## 11 May 2023

## 21081 Sunflower Consolidated SD Phase II / Report Number 008

Figure 8 – GHS; will flashing be pinned between new construction & old?

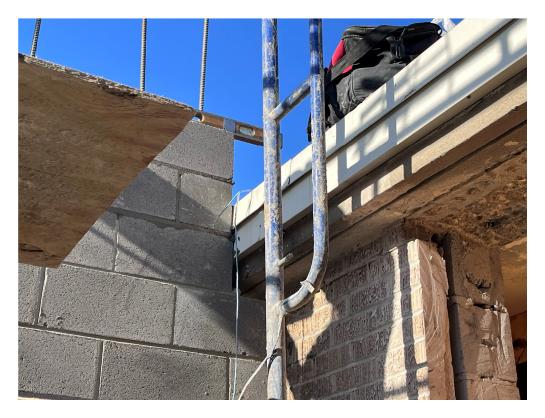
At the north corridor, masons appear to be blocking around roof flashing (see figure 8); this flashing should be removed so that it is not pinned in; later reroofers, will have issues removing without damaging property if

flashing remains trapped.

Figure 9 – GHS; please advise on deformation in column

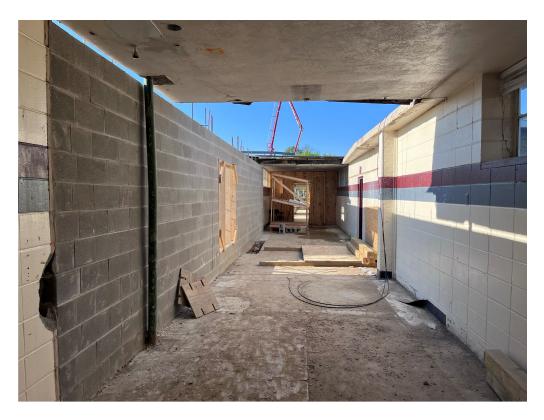
In the N/S corridor on the west side of campus, there is a column that appears deformed (see figure 9). Coordinate with structural to confirm

this deformation does not exceed allowed tolerances.

Figure 10 - GHS Exterior Wall where proposed bump out will be seen at interior

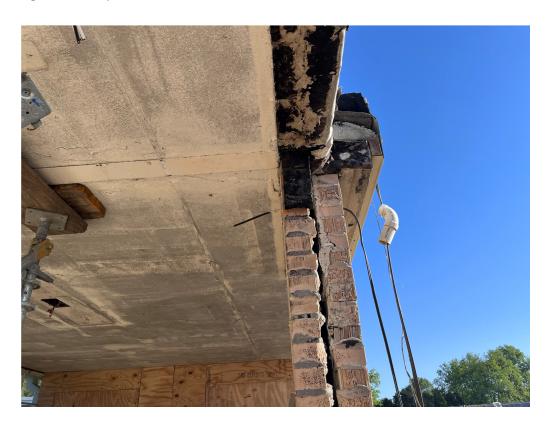
Figure 10 shows the location of a double brick wall that will be adjoined by new. There is an RFI out requesting clarification on the new adjoining wall. The brick veneer of the new wall should be flush with the exterior of this wall. There will be a bump out of CMU here in the hall.
